CITY OF ALBUQUERQUE

Re: Coal Street Townhomes, 1607 Coal Street SE, Traffic Circulation Layout
Architect's Stamp dated 05-01-09 (K15-D092)

Re: 1607 Coal Ave SE Grading and Drainage Plan
Engineer's Stamp dated 9-7-10 (K15/D092)

Re: 1607 Coal Ave SE Grading and Drainage Plan
Engineer's Stamp dated 8-9-10 (K15/D092)

COA DETAIL 2425 [partial]

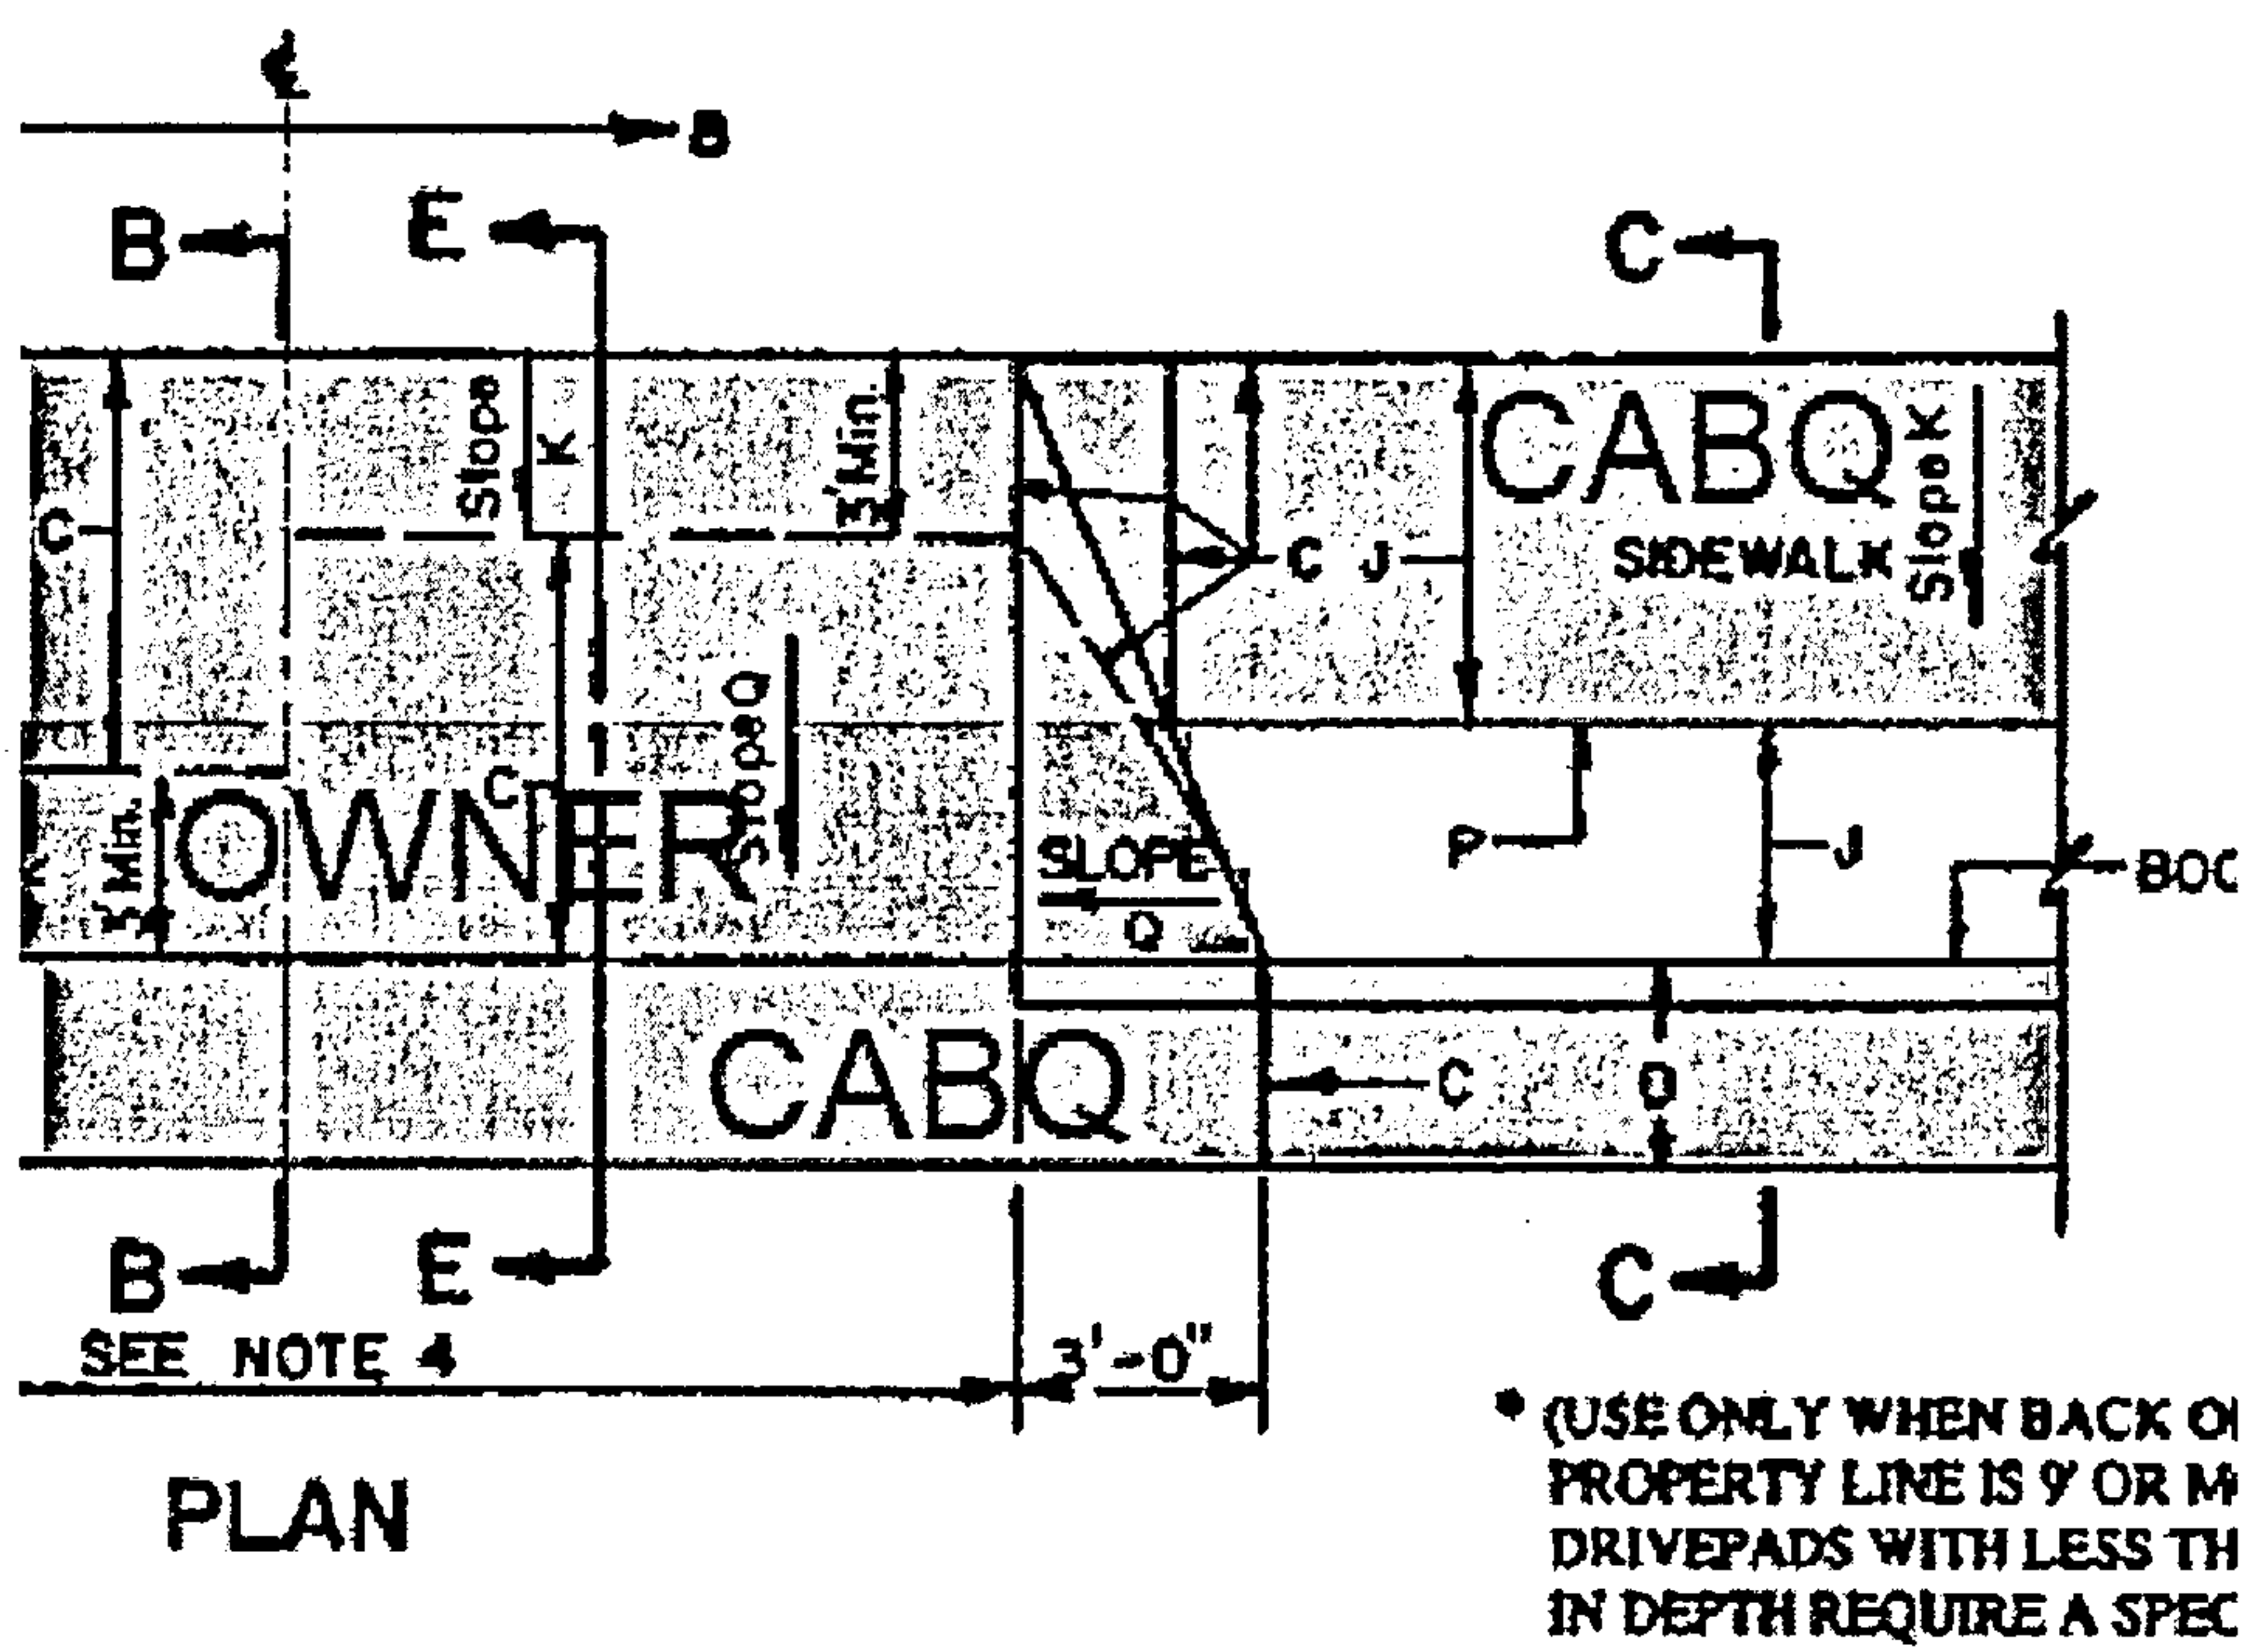
- [1] Demo curb and gutter immediately (it is pulverized at this point anyway)
- [2] Install temporary asphalt for **interim access** (4 months)

- [3] Incorporate this drive pad in your CD's
- [4] Install of driveway profile in lieu of curb/gutter configuration and install sidewalk as currently designed
- [5] Make necessary landscape adjustments (actually a savings in plant material)
- [6] My team can then come back and complete the drive pad infill per COA 2425 between gutter and sidewalk. Naturally I would prefer CABQ just do the whole drive pad like the many others already in place, but you will note I have not requested that, and will do the infill after CABQ is out... or I can pay the Contractor directly for the 'extra' 1.75 cu yds required to complete the drive pad.

I'm simply requesting that the concrete you would be placing anyway be warped to meet the needs of the std detail driveway, at the grades that you are uniquely privy to. This solution brings the much needed coordination and will result in a better end product for all parties.

Due to your timeline and need for access, if Richard Dourte and Kristal Metro are ok with your temporary asphalt proposal it seems reasonable to me. Our Lead & Coal project will construct the curb & gutter and sidewalk in place as per the design plans. You will design your driveway with this new scenario and we can review. We will leave landscaping out of this vicinity. You will come in and complete the construction of the remaining portion of the drivepad (as the sidewalk is part of that driveway).

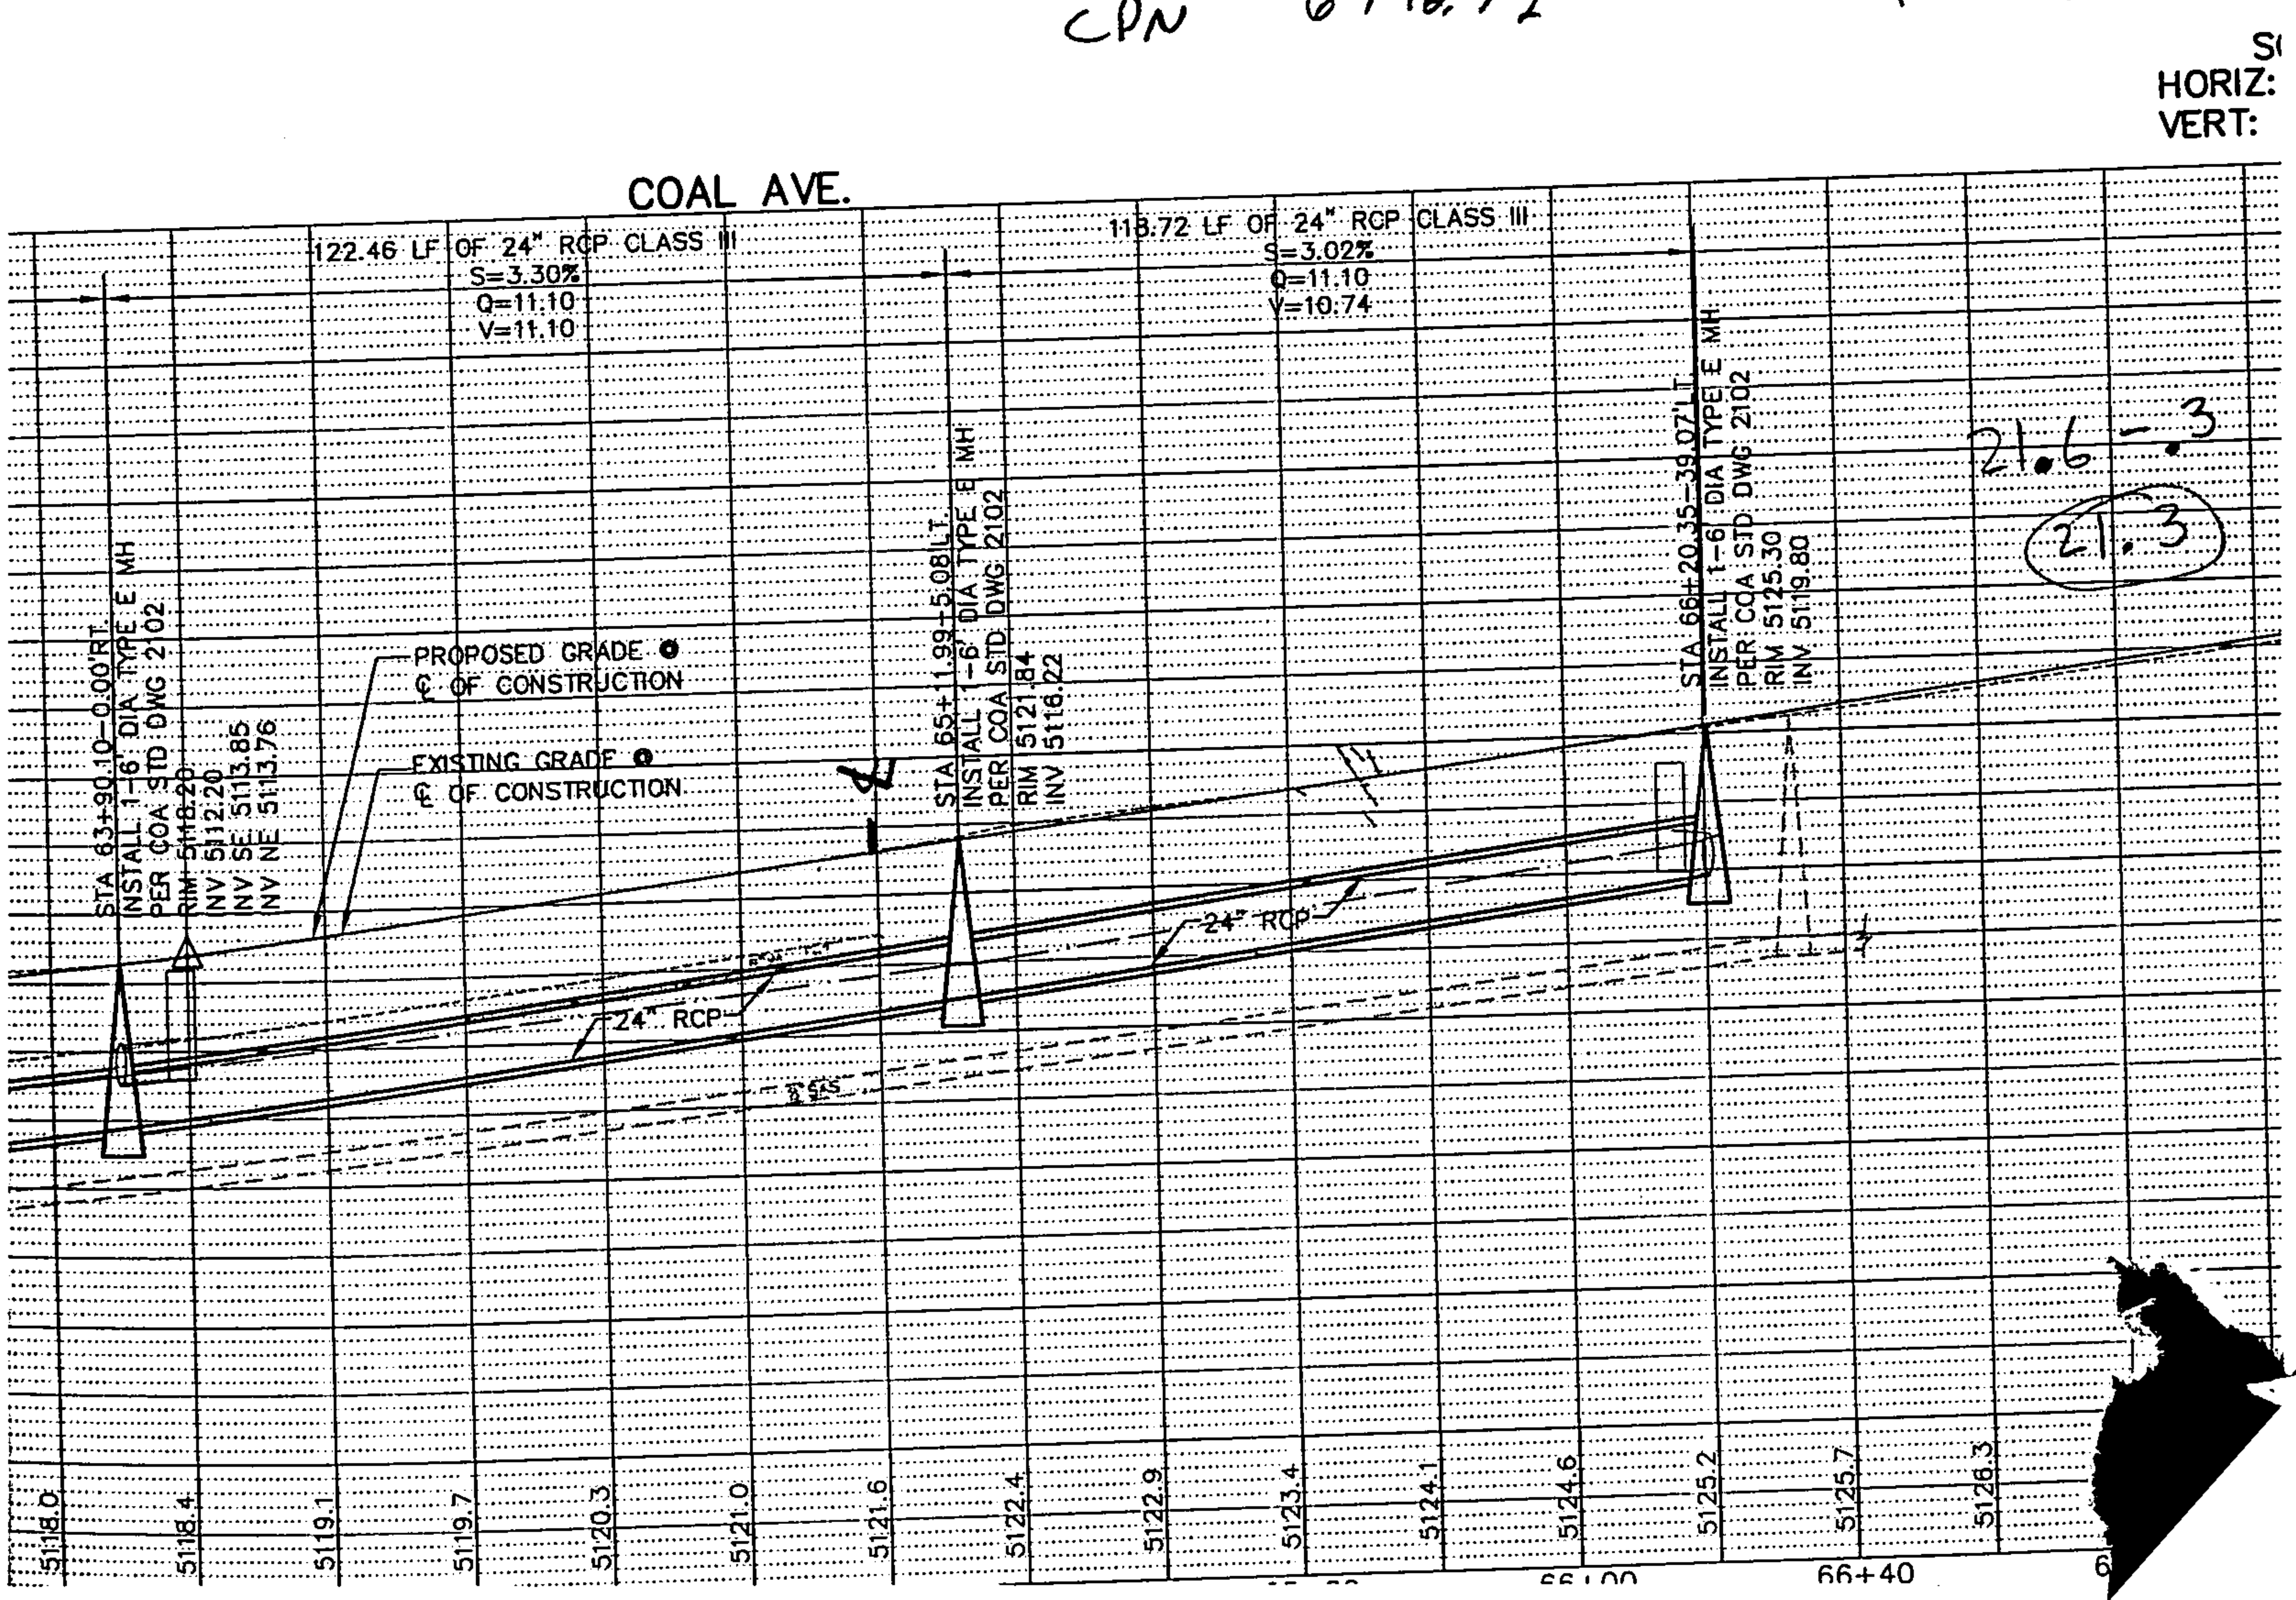
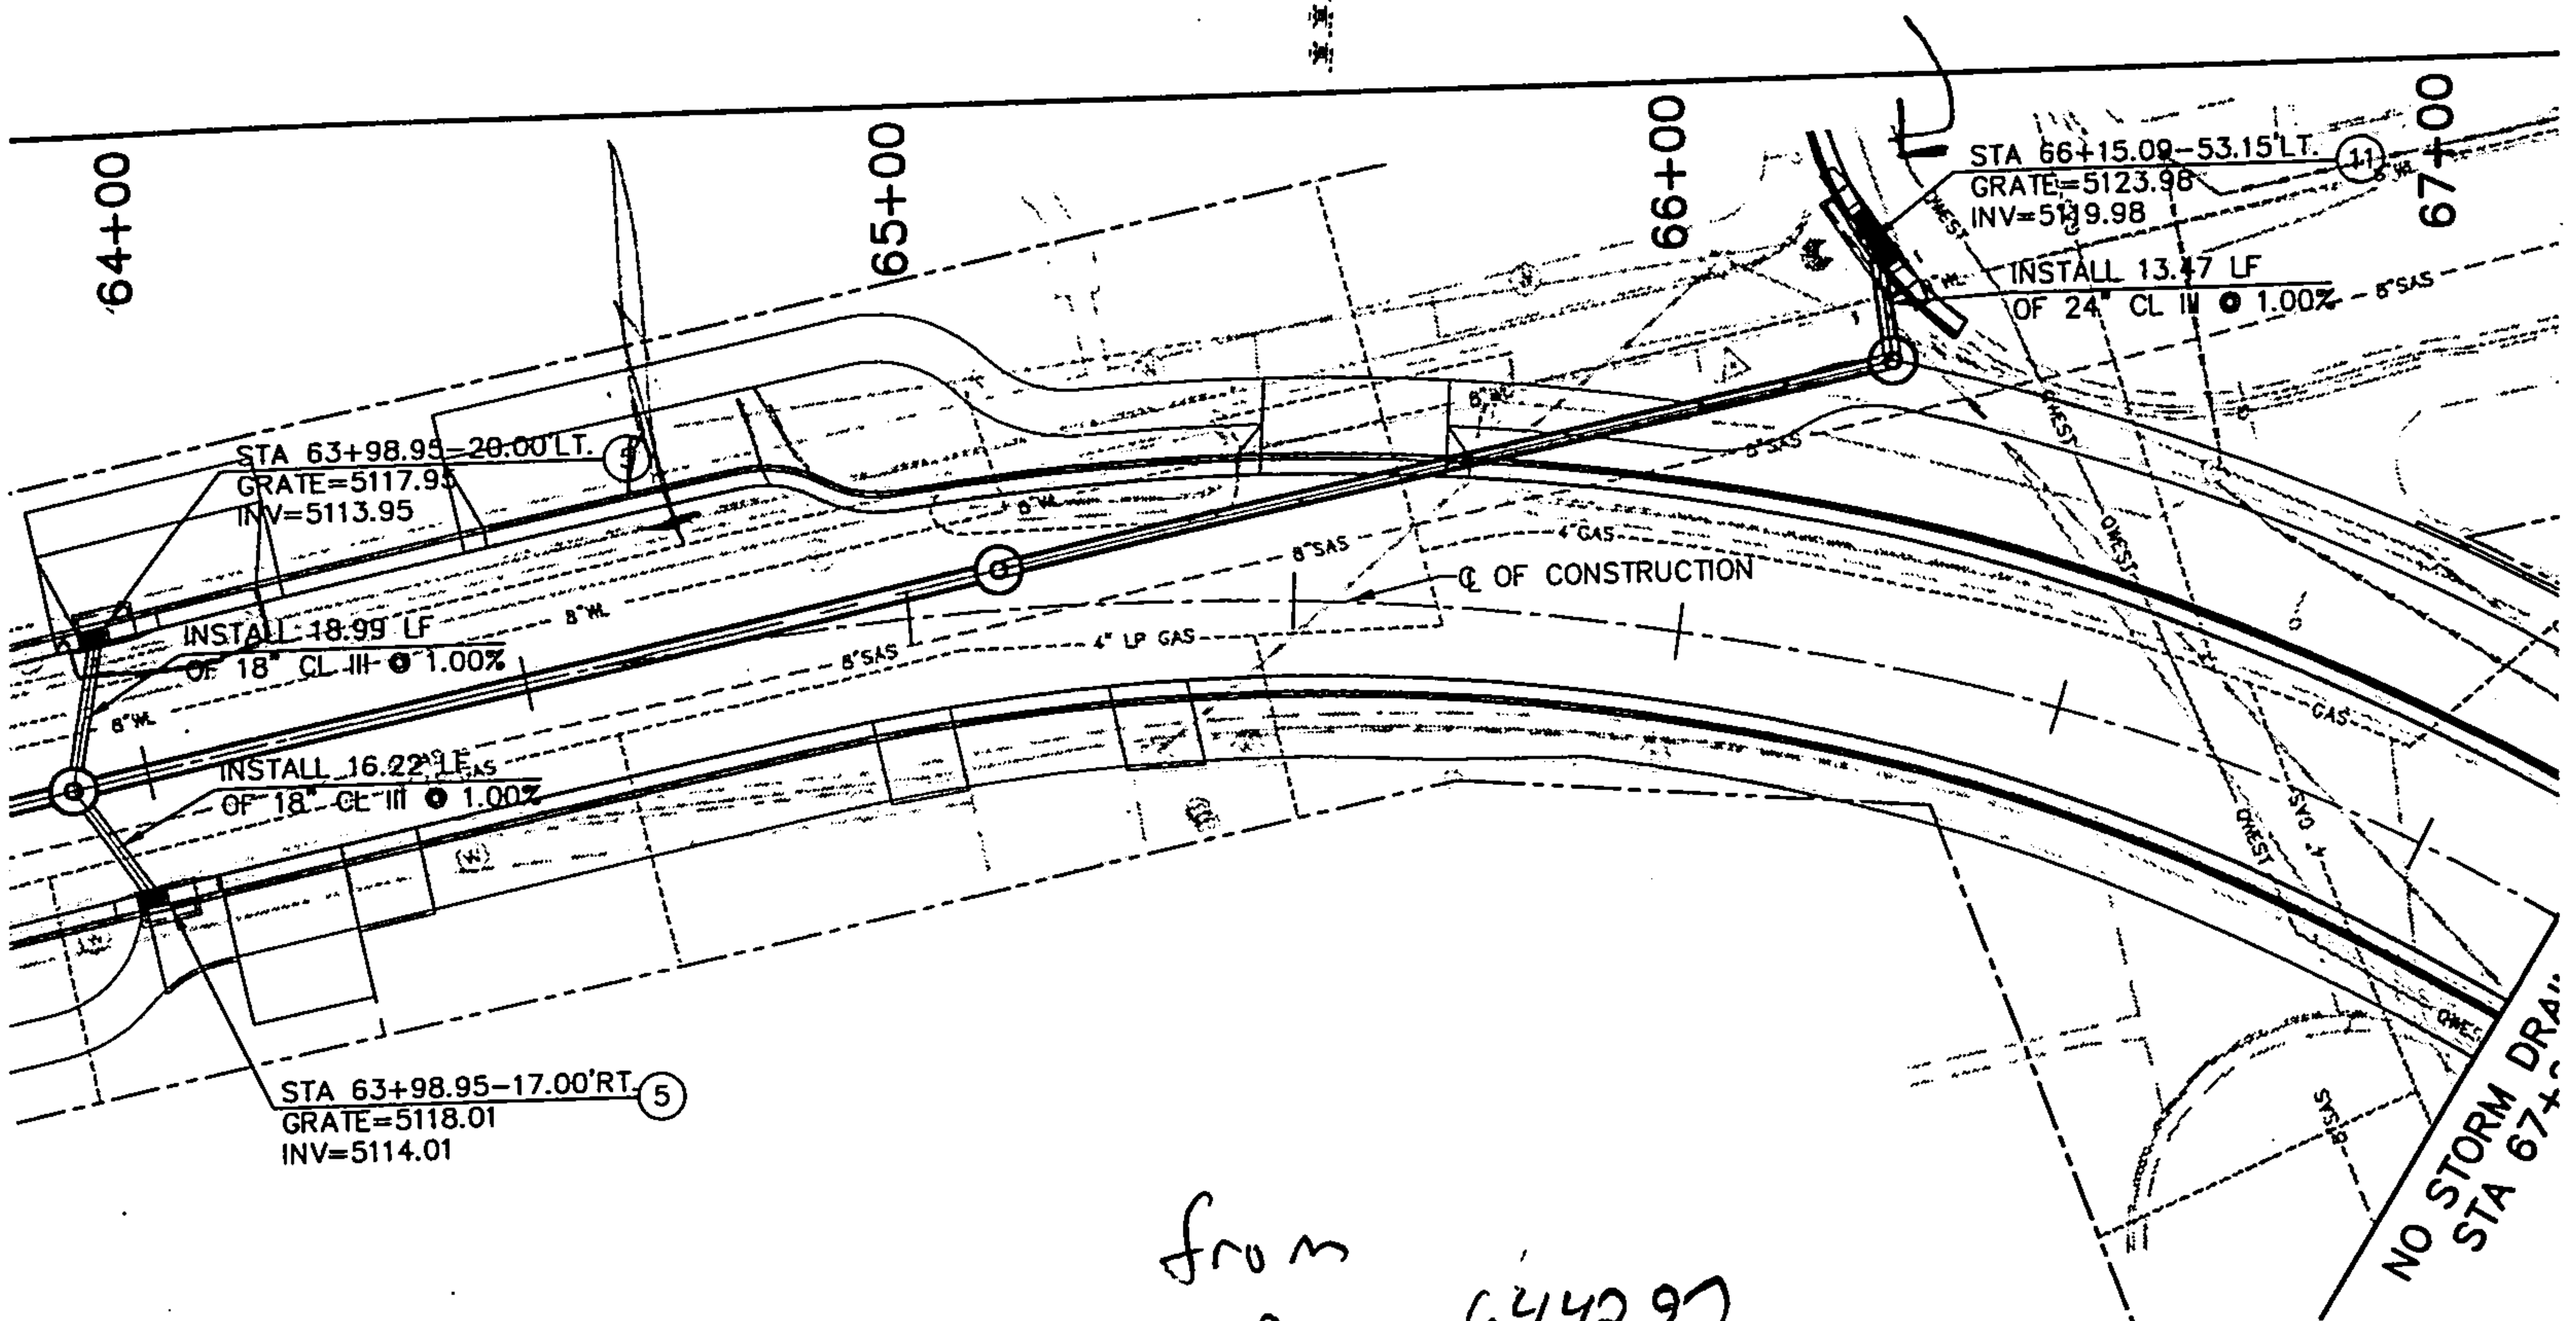
- A more substantial water block is required along Coal Ave. The grade at the property line should be at least as high as the existing back of sidewalk grade and the north end of the drive pad should be at least 6 inches above the flow line in Coal Ave.
- Provide the direction of roof flows.
- For your information, CPN 6442.92 by Wilson & Company, has proposed moving the curb about 3 feet north in the vicinity of this project.
